Access Compliance Report

Public Rights-of-Way

(Curb Ramps)

Intersection ID: 49555	Main Street: ARTISTS_WY	Cross Street: STEEL_GARDENS_BV	Location: S
ADA ID: A31A1233B883	Ramp Type: Perp	Initial Pass/Fail: Fail	Overall Compliance: No
Severity Score: 21.25			
Codes/Mitigation Info/Possible Solution		Field Measurements/Component Compliance

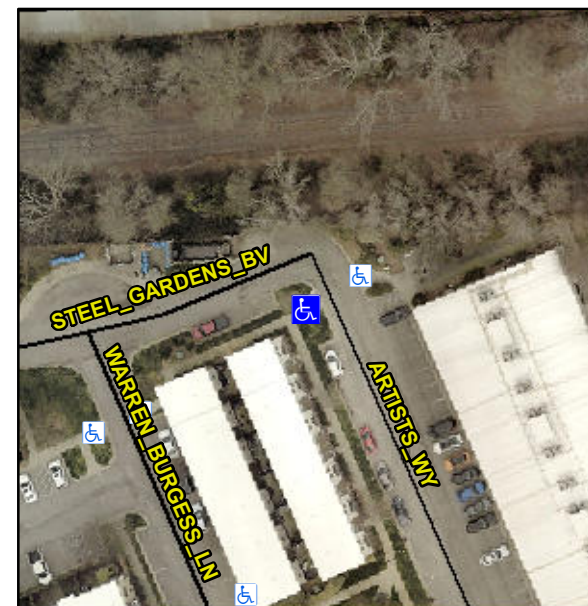
R304.5.1, R304.2.2

Compliance	Description	Data	Compliance	Description	Data
N/A	Ramp Length (in)	100.0	No	Ramp Slope (%)	8.4
No	Ramp Width (in)	47.0	Yes	Ramp XSlope (%)	1.0
N/A	Flare Type LT	N/A	N/A	Flare Type RT	N/A
N/A	Flare Slope LT (%)	N/A	N/A	Flare Slope RT (%)	N/A
N/A	Flare Traversable LT?	N/A	N/A	Flare Traversable RT?	N/A
N/A	Landing Length (in)	N/A	N/A	DWS Provided?	N/A
N/A	Landing Width (in)	N/A	N/A	DWS Contrast?	N/A
N/A	Landing Slope (%)	N/A	N/A	DWS Length (in)	N/A
N/A	Landing X Slope (%)	N/A	N/A	DWS Full Width?	N/A
N/A	Landing Curb? (Y/N)	N/A	N/A	DWS Offset (in)	N/A
N/A	Shared Landing?	N/A			
N/A	Gutter Ponding?	N/A	N/A	Gutter Slope (%)	N/A
N/A	Gutter Lip Ht (in)	N/A	N/A	Gutter X Slope (%)	N/A
N/A	Painted X Walk1?	No	N/A	Painted X Walk2?	N/A
	X Walk 1 Direction	To NE		X Walk 2 Direction	N/A
N/A	X Walk 1 Width (in)	N/A	N/A	X Walk 2 Width (in)	N/A
	X Walk 1 Slope (%)	3.4		X Walk 2 Slope (%)	N/A
	X Walk 1 X Slope (%)	2.6		X Walk 2 X Slope (%)	N/A

Remove & Replace Entire Ramp.
